City of **HOBART**

## APPLICATION UNDER HOBART INTERIM PLANNING SCHEME 2015

Type of Report: Committee  
Council: 21 May 2018  
Expiry Date: 22 May 2018  
Application No: PLN-18-54  
Address: 1 HARBROE AVENUE , NEW TOWN  
ADJOINING RIGHT OF WAY  
Applicant: Matthew McIntyre  
615 Cambridge Rd  
Proposal: Multiple Dwelling, Fencing and Associated Hydraulic Infrastructure  
Representations: None  
Performance criteria: Parking and Access Code and Heritage Code

Figure 6: Proposed Site Plan

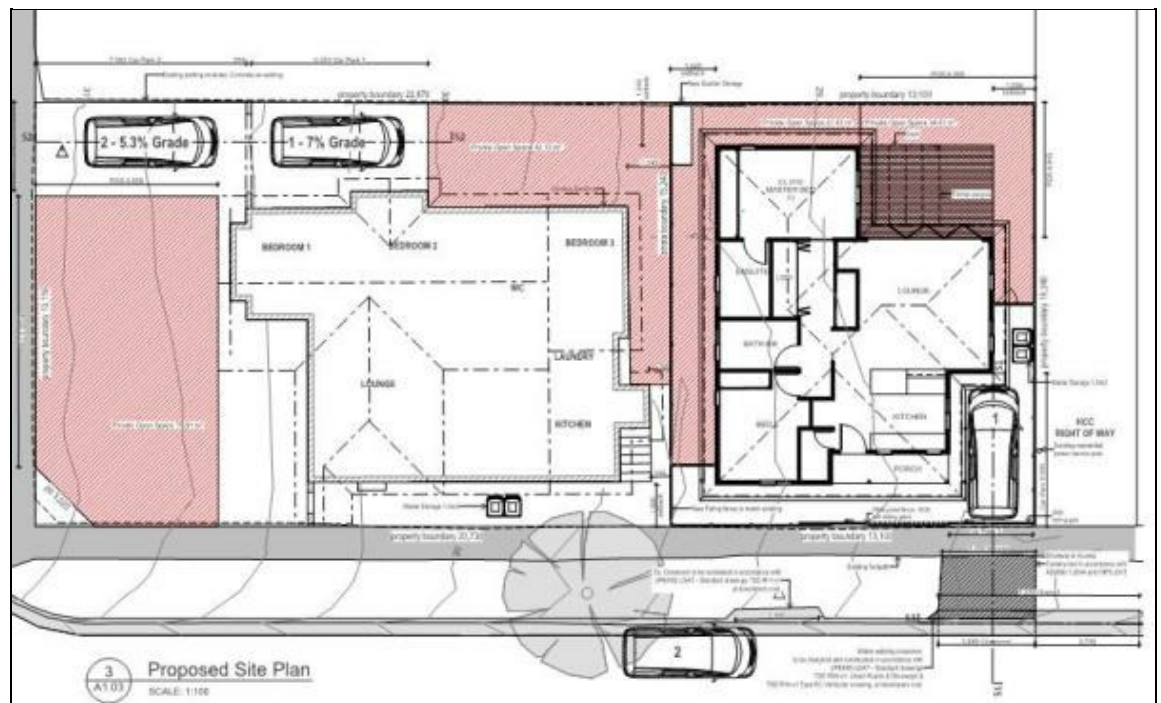
- 6.9.1 The acceptable solution at clause Part E6.7.12 A1 requires car parking to be behind the building alignment.
- 6.9.2 The proposed car parking space extends 900mm past the building alignment.
- 6.9.3 The proposal does not comply with the acceptable solution; therefore

- 6.9.5 The majority of the car parking space is located behind the building line. Altering the existing design to achieve the full extent of the car parking space behind the facade would result in unnecessary reduction of the living area and private open space of the proposed dwelling. The parking is a space only not a garage or carport and the front facade of the dwelling is still the dominant feature within the frontage of the site.
- 6.9.6 The proposal complies with the performance criterion.
- 6.10 Historic Heritage Code – Part E13.8.1 and E13.8.2 Heritage Precinct
- 6.10.1 The subject site is within Heritage Precinct. Assessment against the following performance criteria is relied on.

The proposed house is a single storey house in FC weatherboard and with a corrugated iron roof. A new timber picket front fence along Bishop Street is proposed and is 1.0 metre high. The front gate to the house and the sliding vehicular gate is of a similar height.

One outcome of this proposal will be the loss of rear garden space on the northern side of the existing house, such that the proposed strata boundary in the form of a paling fence is reduced to between 760 and 1540 mm from the rear of the existing house and 1600 mm from the proposed house. The remaining open space for the existing house is its front yard.
